REFERENCE No. B. S. P. 387 OF 1932.

PLAN SHOWING THE PROPOSED BUILDING ON PLOT
N^o 24 M.R. 7 MARKET QUARTER.

PLAN SHOWING PROPOSED BUILDING
ON PLOT NO 24 M.R.7 MARKET QRT.

PLAN OF PROPOSED BUILDING ON PLOT NO 24 M.R. 7

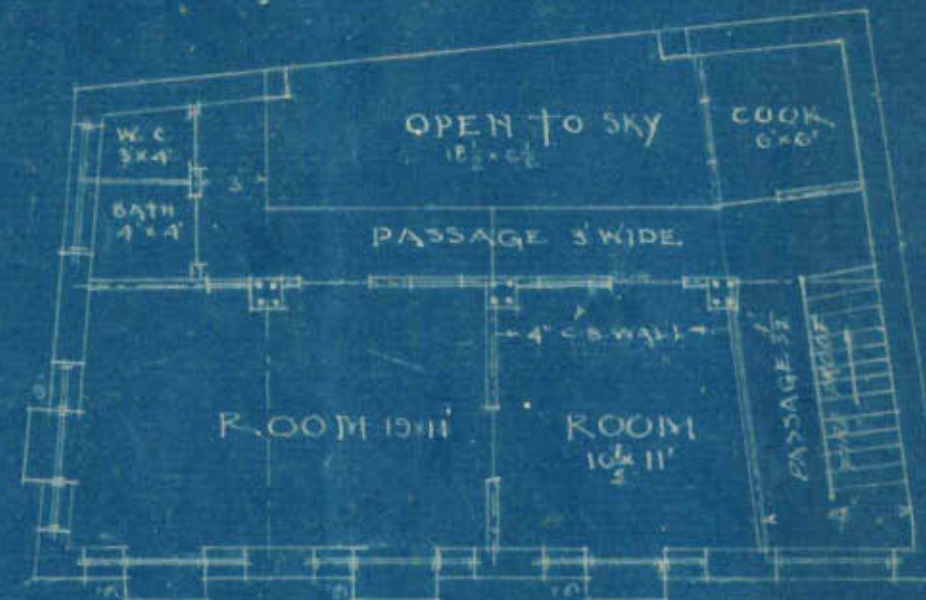
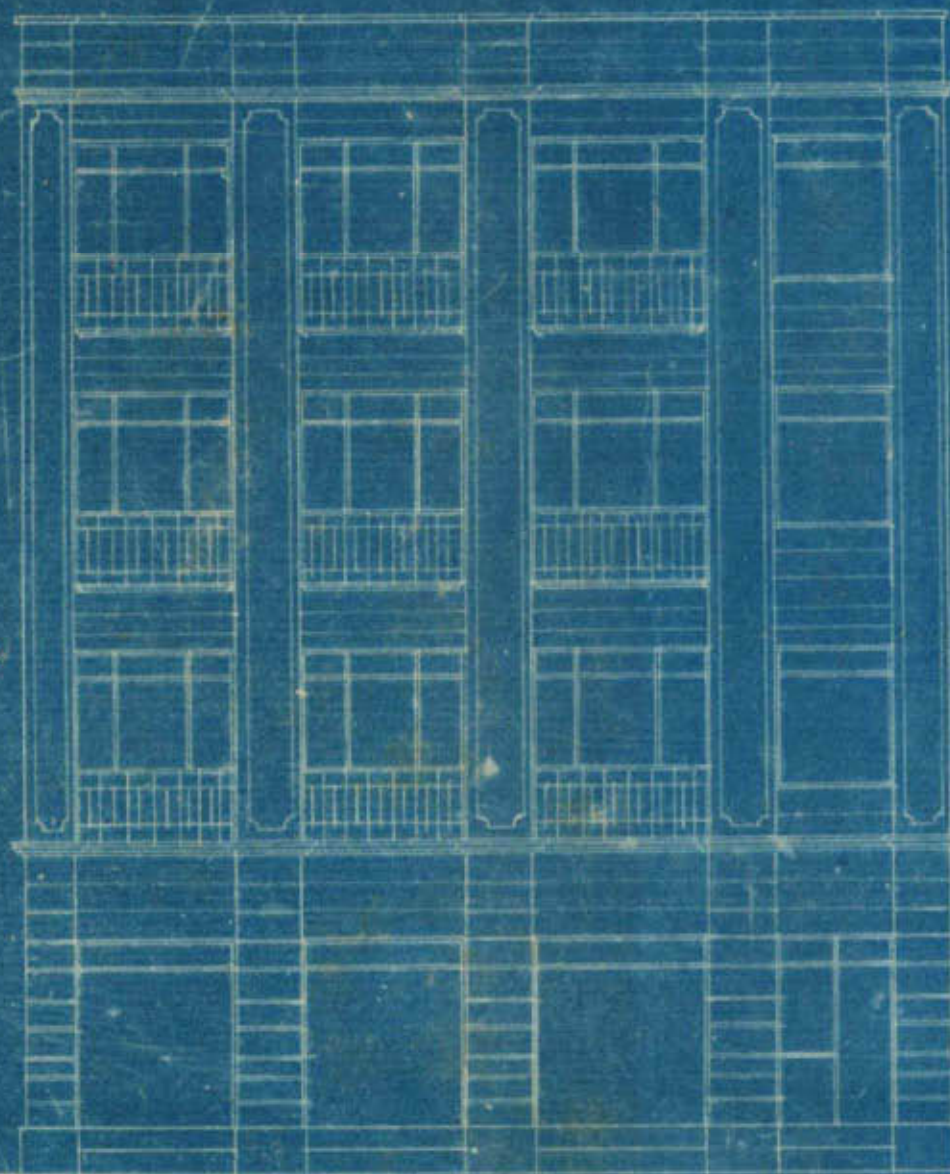
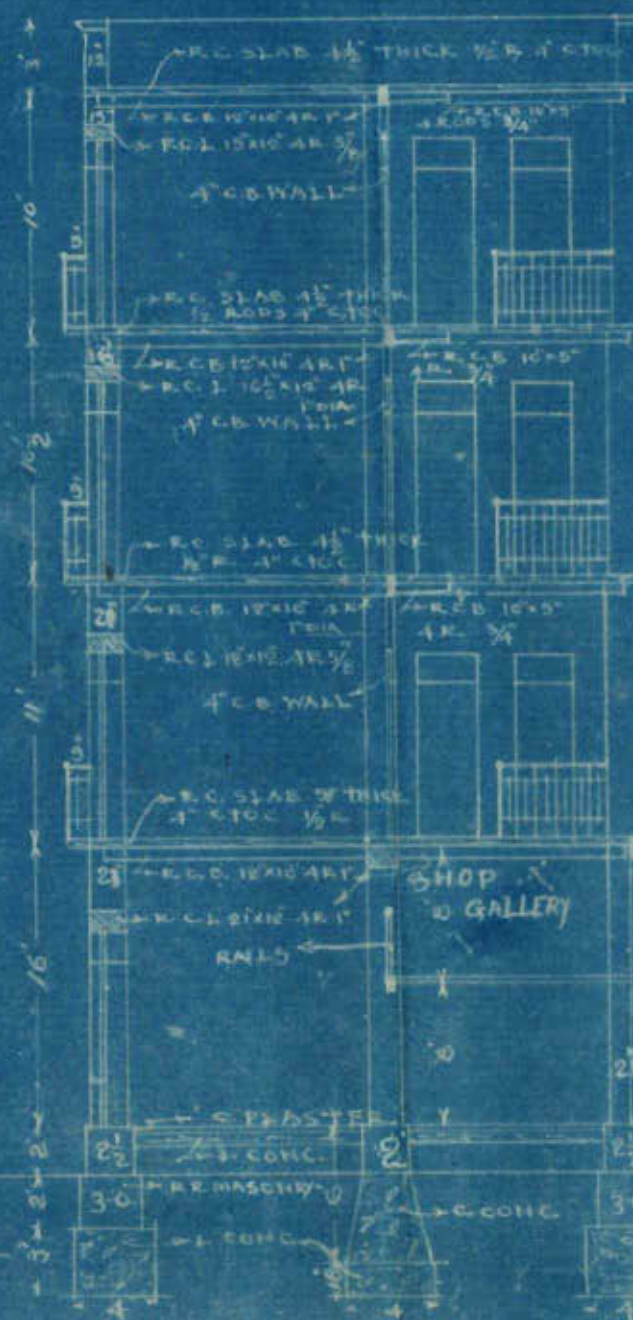
Sanitary conveniences should be provided on the ground plan of shop keepers.

- 1) Loft cannot be allowed and it must be deleted
- 2) Open space be taken right from the ground floor.
- 3) Front wall of pillars be prepared of R.C. as they carry the beam ends
- 4) Sizes of all beams etc must be written down on the plans
- 5) Staircase passage be made 7' wide and width of the flight of stairs be made $3\frac{1}{2}'$.
- 6) Plans are very faint and unreadable. Clear blue prints must be submitted.

- 1) Alignment is wrongly shown - It must be corrected.
- 2) Widths of Roads are wrongly put down and require to be corrected.

- (1) Sanitary Amenities should be provided on
- (2) the ground floor for Shop keepers
- (3) Loft cannot be allowed & it must be deleted
- (4) Open space be taken right from the ground floor
- (5) Front wall of pillars be proposed of R.C. as they
- (6) carry the beam ends.
- (7) Sizes of all beam etc must be written down on
- (8) the plan.
- (9) Shop passage be made 7' wide and set of
- (10) the flight of stairs be made 3 1/2'
- (11) Plans are very faint and inadequate. Clear
- (12) blue prints must be submitted
- (13) walls must be 23', 21', 18' & 15'
- (14) Shop gallery must be written instead of loft
- (15) R.C. to be provided to gallery.
- (16) Front wall on Rumbharthi Street to be made of
- (17) masonry.
- (18) walls must extend up to E.F.

With reference to your letter No.B.
S.P. 389. Dated 25 - 8 - 32. I herewith re-
submit a set of three prints of proposed Build-
ing on plot NO. 24. M. R. 7. Market Quarter
Duly complying with your objections and re-
quest the same be approved at your earliest
convenience & oblige.

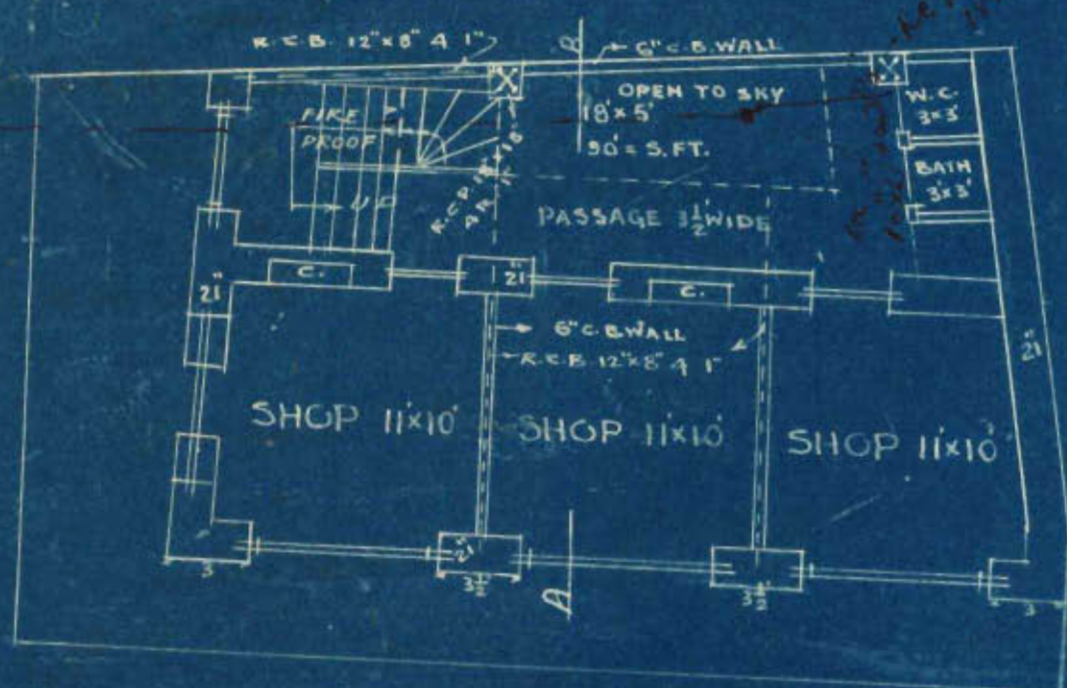
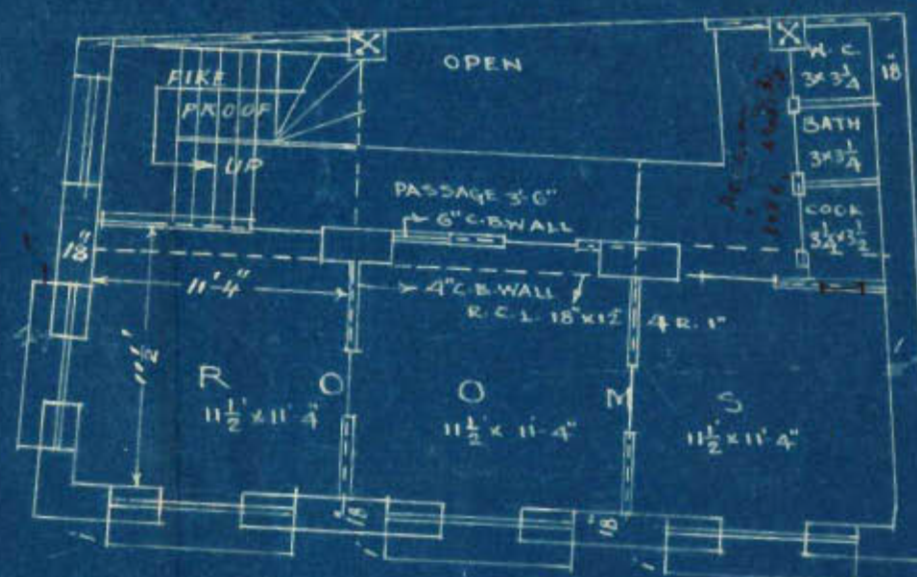
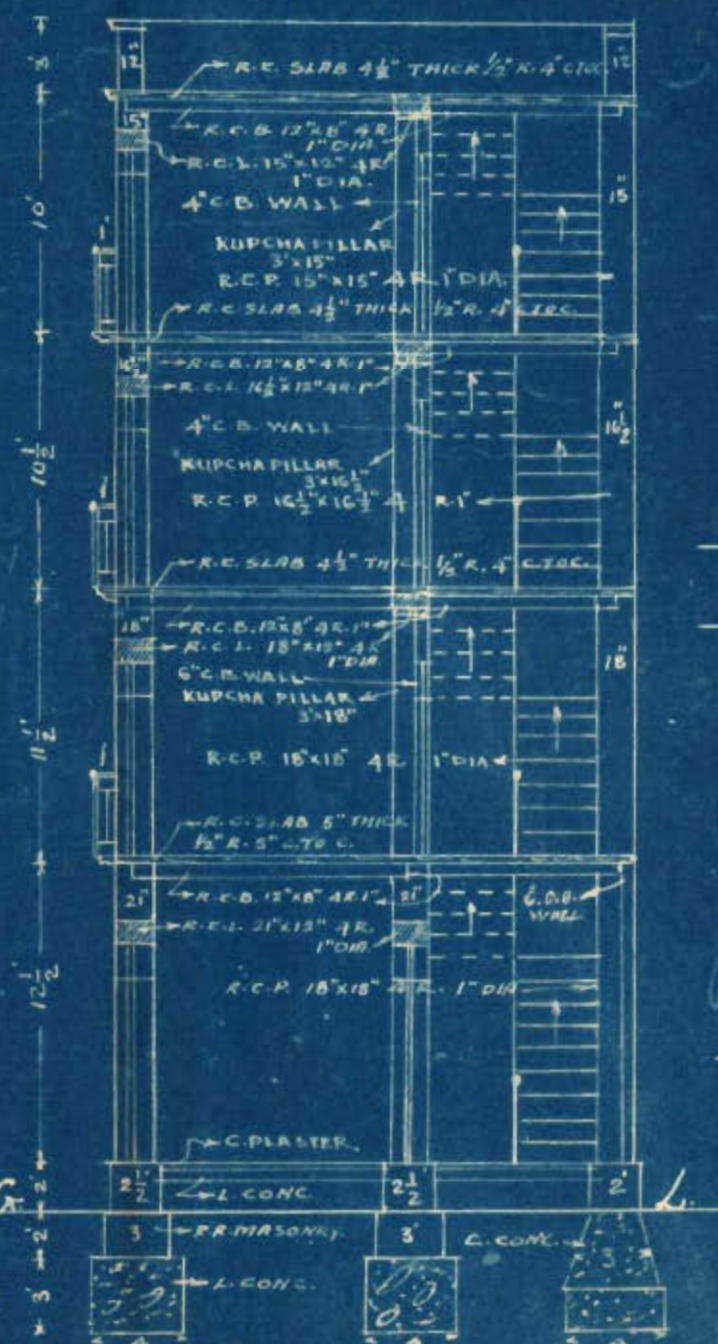
align is not correctly shown the S. Shant Shanti
align must be corrected. $3\frac{1}{2} \times 3\frac{1}{2}$ feet can be
allowed walls will have to be 23, 18, 18 x 15

- (1) Alignment is not correctly shown
- (2) The street shown alignment must be corrected
- (3) $3\frac{1}{2} \times 3\frac{1}{2}$ Kitchen Can't be allowed
- (4) walls will have to be 23, 18, 18 1/2

With reference to your letter No 564
dated Nil I herewith resubmit a set of three
blue prints of Amended plan showing the Propos
ed building on plot No 24 M.P.R. 7 Market Quart.
duly complying with your requirements and re-
quest the same be approved at your earliest
convenience and oblige.

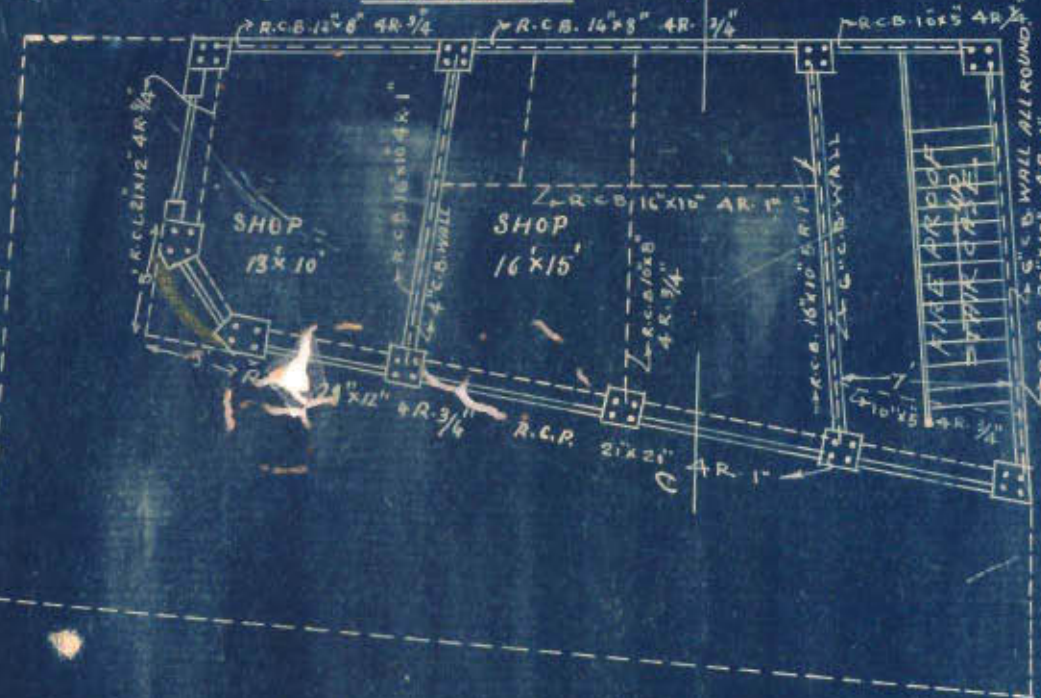
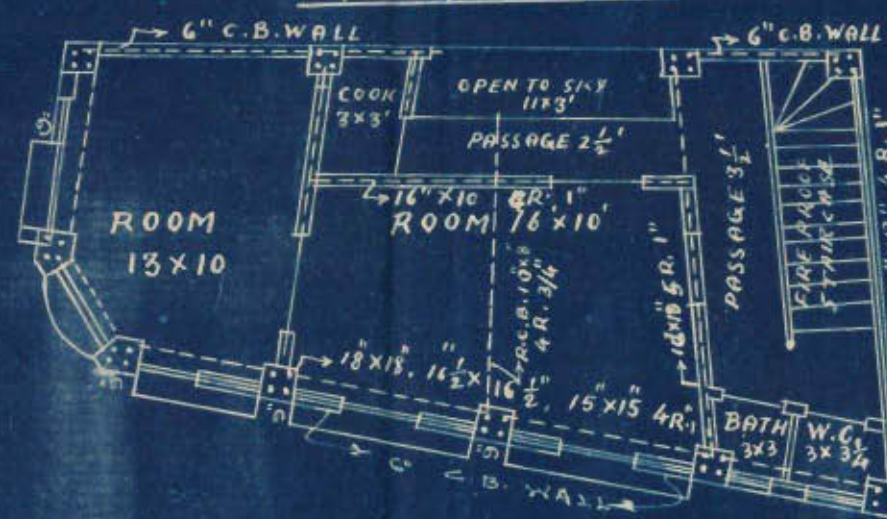
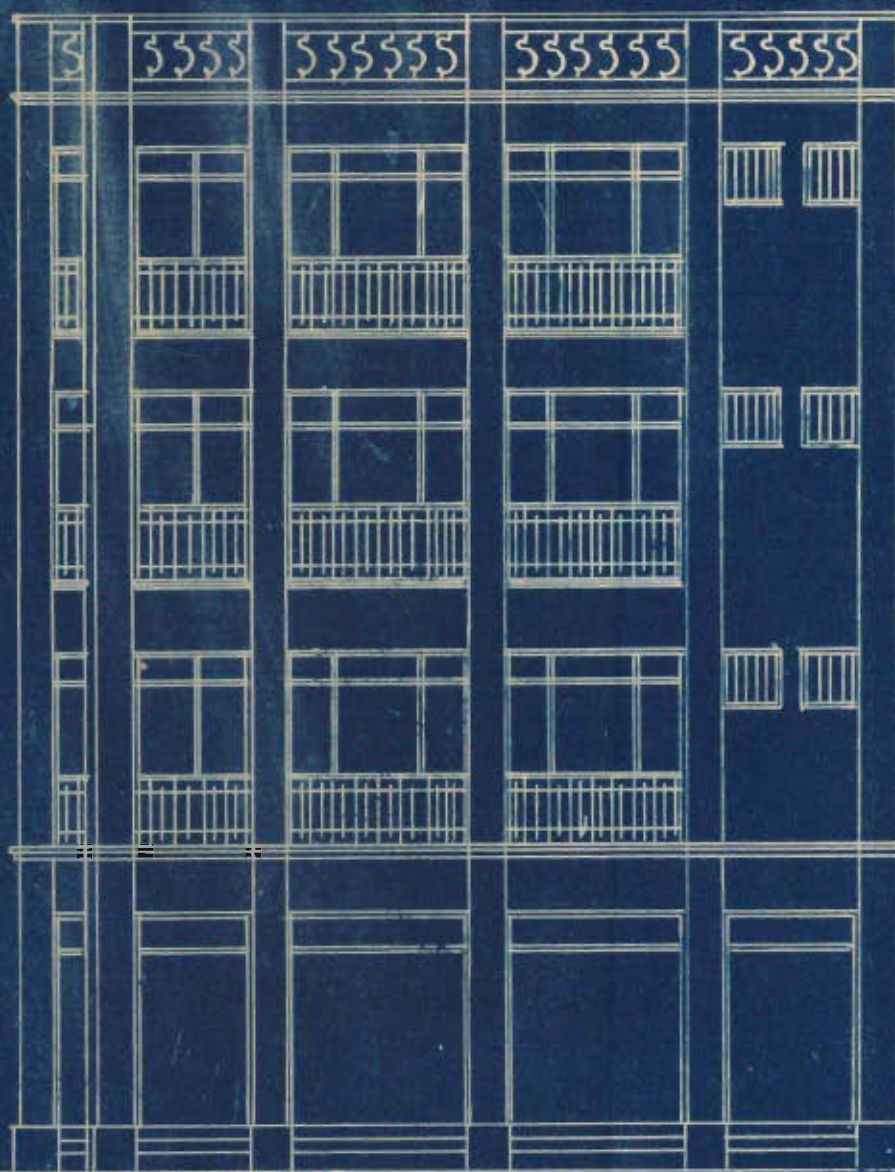
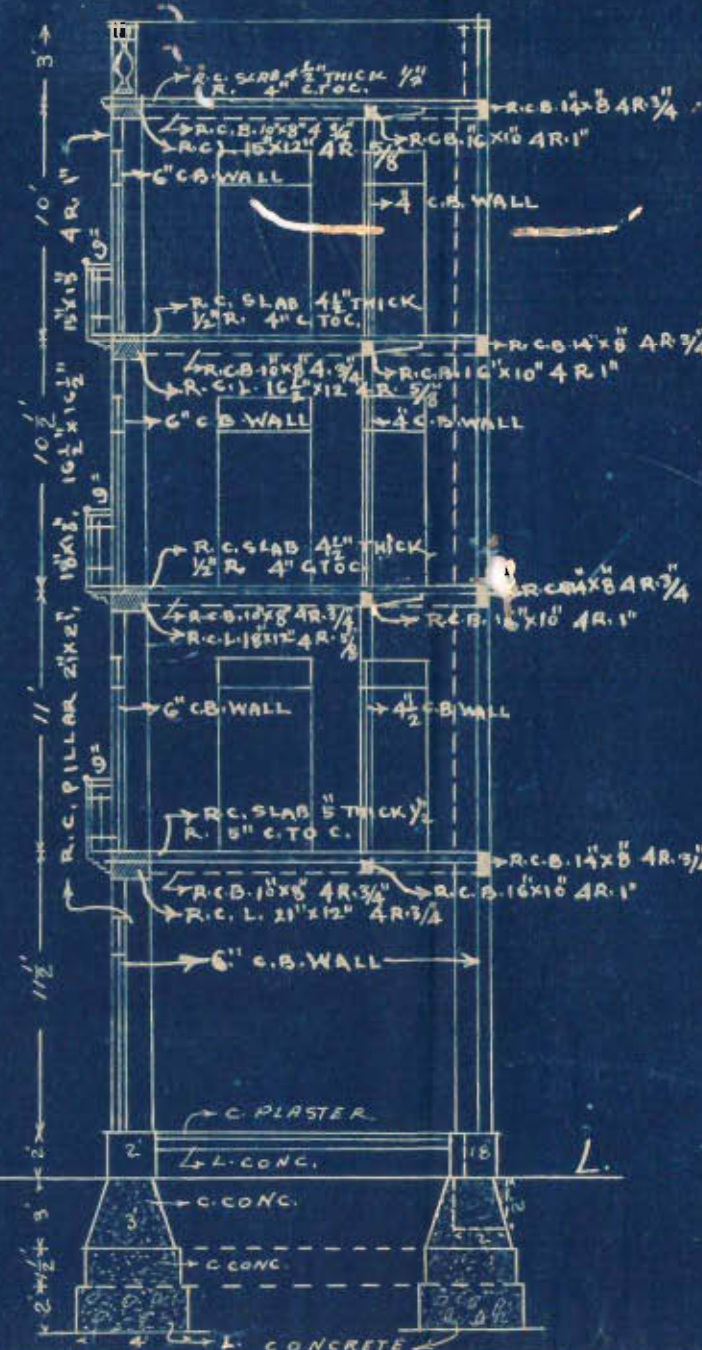
P. write to
 the architect
 to return plans
 and correct
 at once.

- (1) DETAILS & SIZES OF BEAMS ARE AS SAME SHOWN IN G. PLAN.
- (2) DETAILS & SIZES OF R.C. PILLARS ARE AS UNDER :-
 2' x 2' 4R. 1" DIA. FOR G. PLAN & 1ST FLOOR. 18' x 18'
 16' x 16' 4R. 1" " " 2ND FLOOR.
 15' x 15' 4R. 1" " " 3RD FLOOR.
